MAUAO STABILITY ASSESSMENT

Find attached copies of comments from s 7(2)(a) - Privacy regarding the draft report on the above study.

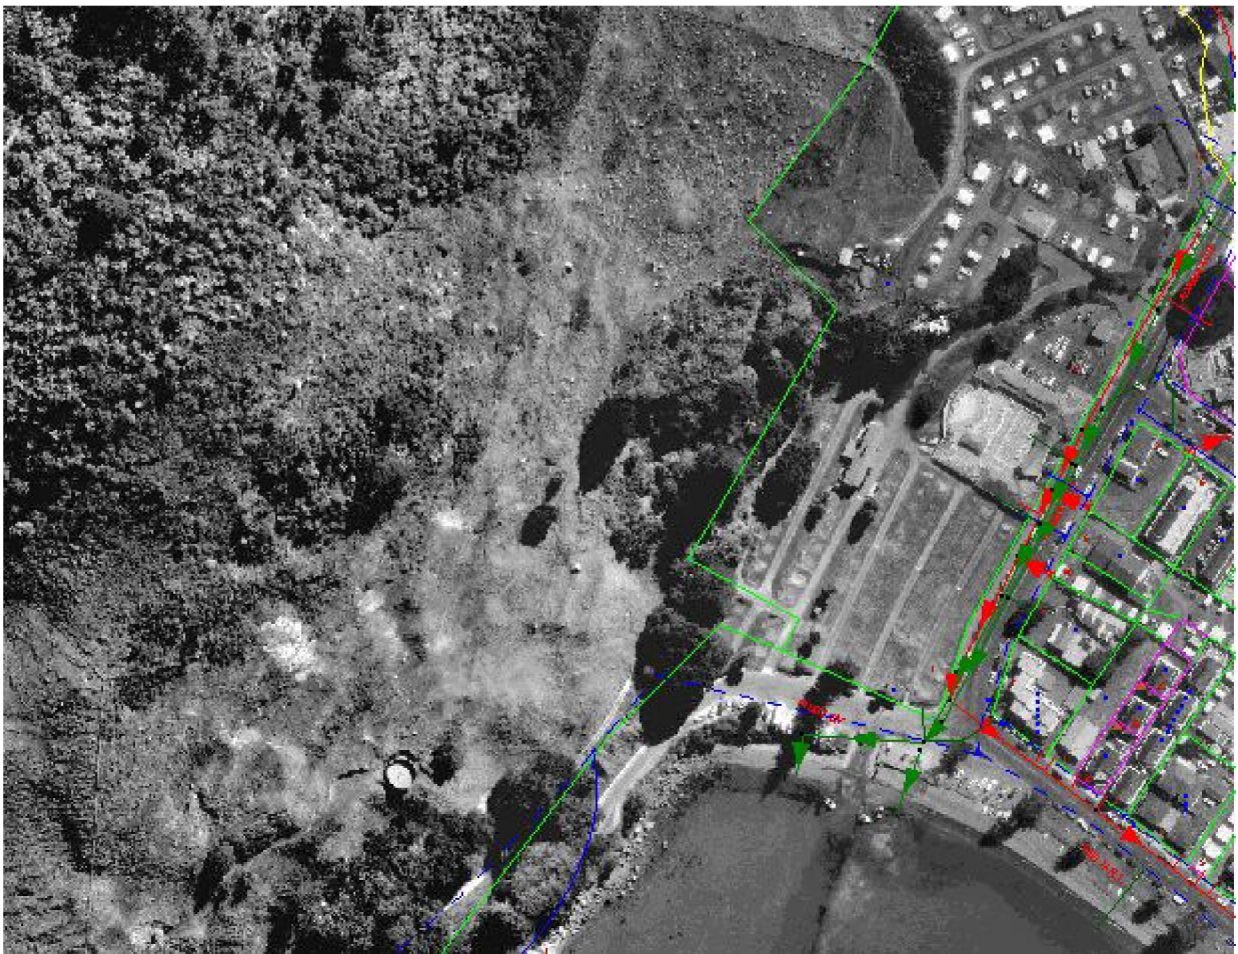
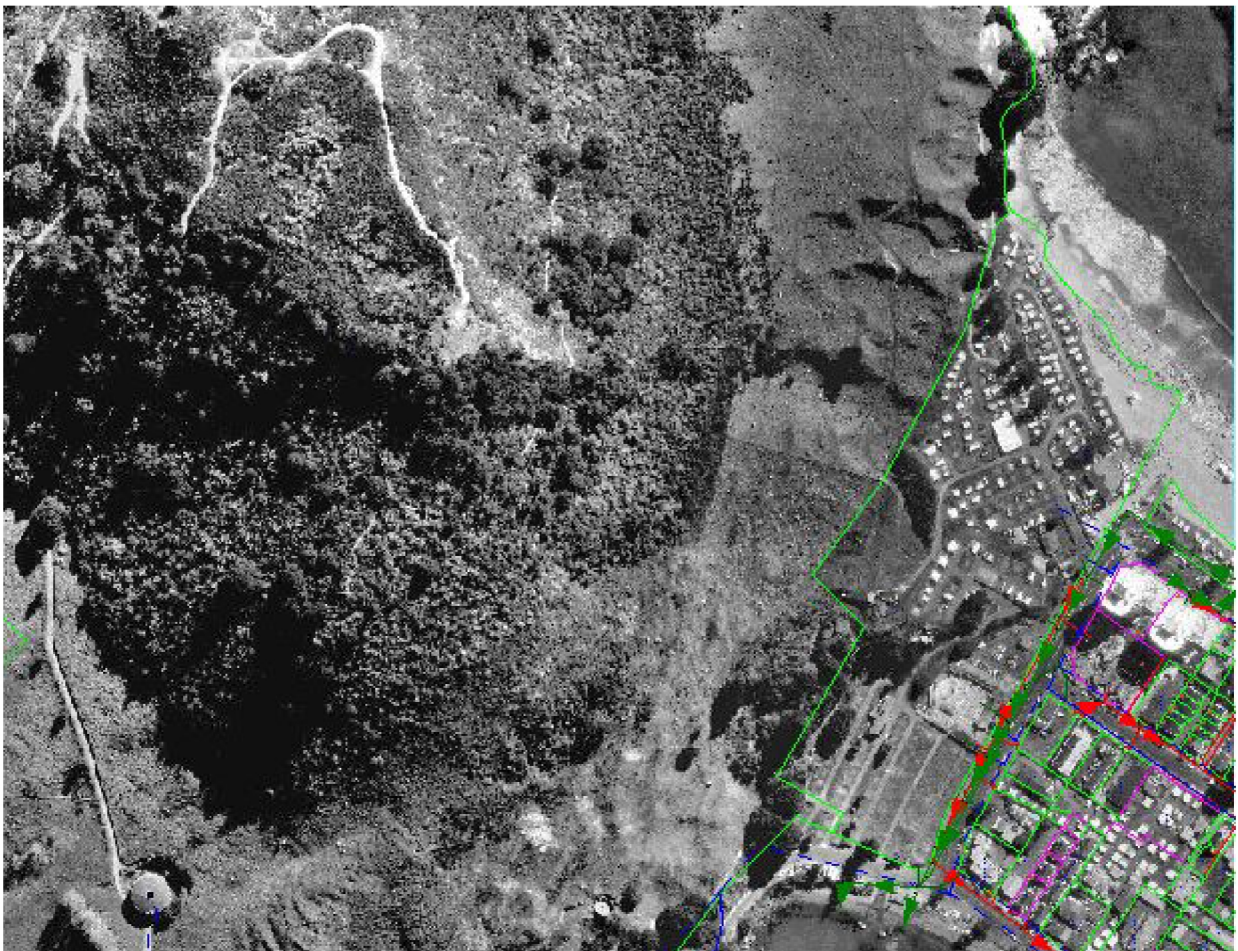
- I have attached the following pictures that maybe of use in displaying the above as well as the Hot Pools and the Motor Camp in relation to the main slip features.
